# Village of Biscayne Park Commission Agenda Report

**Village Commission Meeting Date:** February 2, 2016

**Subject:** Discussion Item – Landscape Design for Community Signage

- Savino Miller Design Studio Community Signage Project Landscape Project Sheets L-1 & L-2
- Email from Barry Miller, dated January 21, 2016

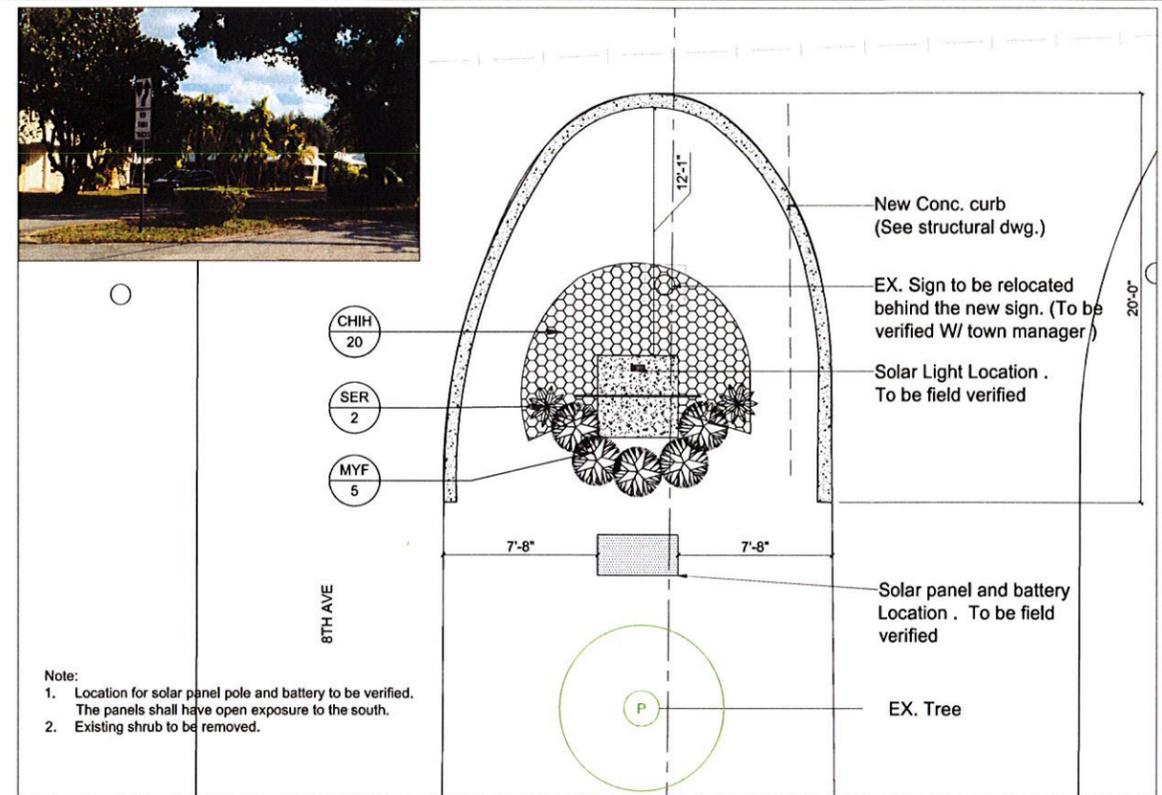
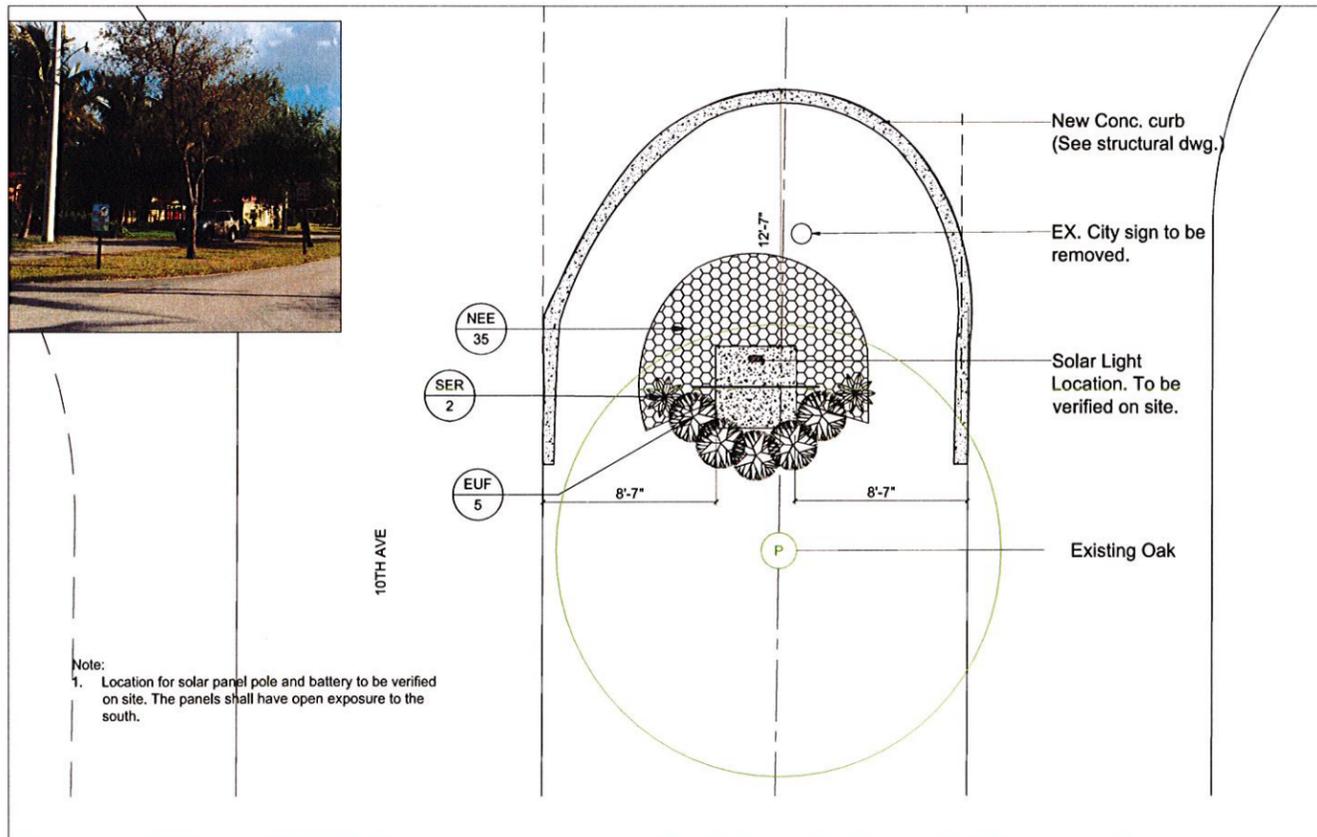
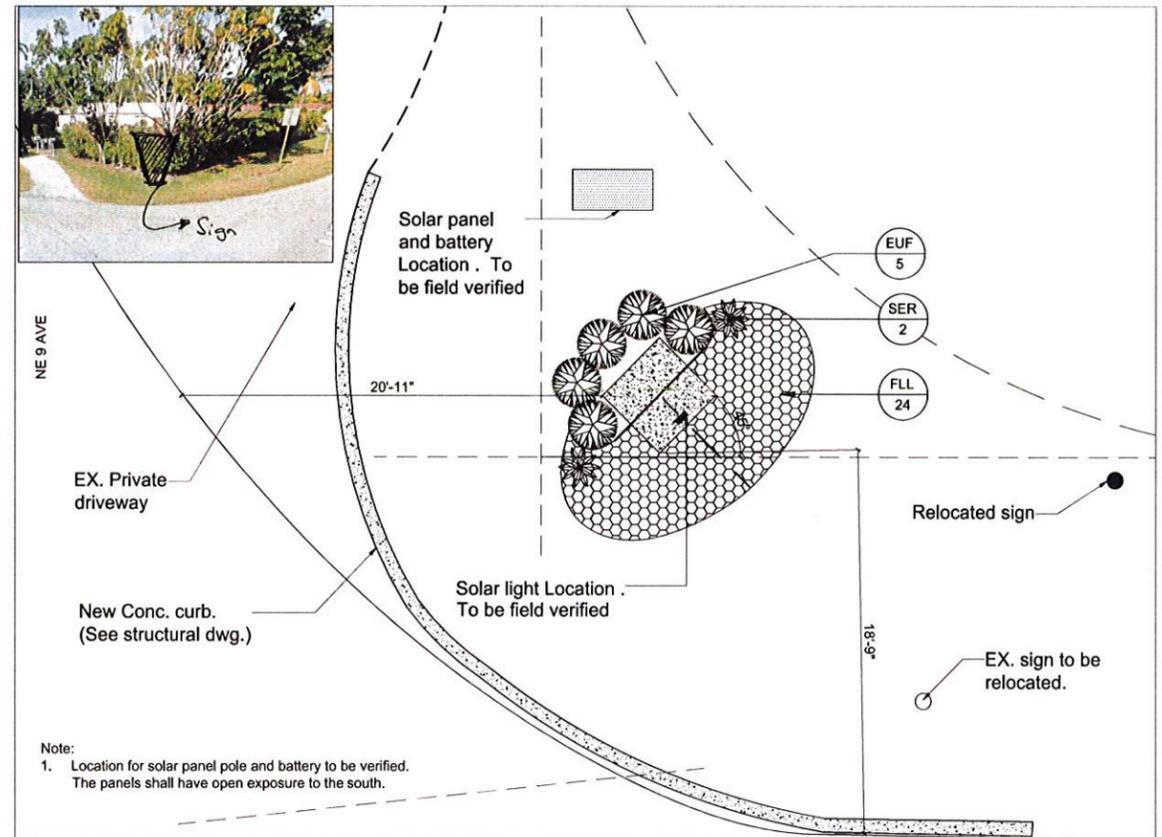
The Parks and Parkways Board expressed an interest in the plans provided by Savino Miller Design Studio and upon review of the plans requested to meet with a representative of the firm. During this subsequent meeting, the Board and Barry Miller of the firm discussed a plan that would include a gravel or shell rock base, one Silver Saw Palmetto and a few native small plants. (See attached email summary from Barry Miller)

Overall, everyone seemed very happy with the sign installation. Mainly, there were questions and concern regarding the need for extensive planting at each of the sign bases, and included the following:

1. The signs are set a little lower than the surrounding curb, and there is concern that adding even low (12" - 18") groundcover planting would cover up too much of the sign. There was general consensus that some kind of gravel - or coquina shell could be placed as a "mulch", 4" deep, with roughly 2.5 CY at reach of the signs. One "Silver Saw Palmetto", as large as practical, would be planted behind the sign to screen to back side somewhat, and the City could plant a few native, small plants, scattered informally, on the sides and back of the sign that would not hamper visibility of the sign or sight lines. Many plant options were discussed as well. Dan (or someone) would get samples of the gravel/shell for approval by the Board/City.

2. Lack of irrigation, which limits what kind of drought tolerant planting material would perform best. There was agreement that the Village should plan to water these plants during "drought" periods.

We also briefly discussed the issue of solar lights, and confirmed that the upright would be placed in front of the sign (not the back) and that the solar panel would be remotely sited so as not to conflict with the sign aesthetic and to maximize sun exposure.
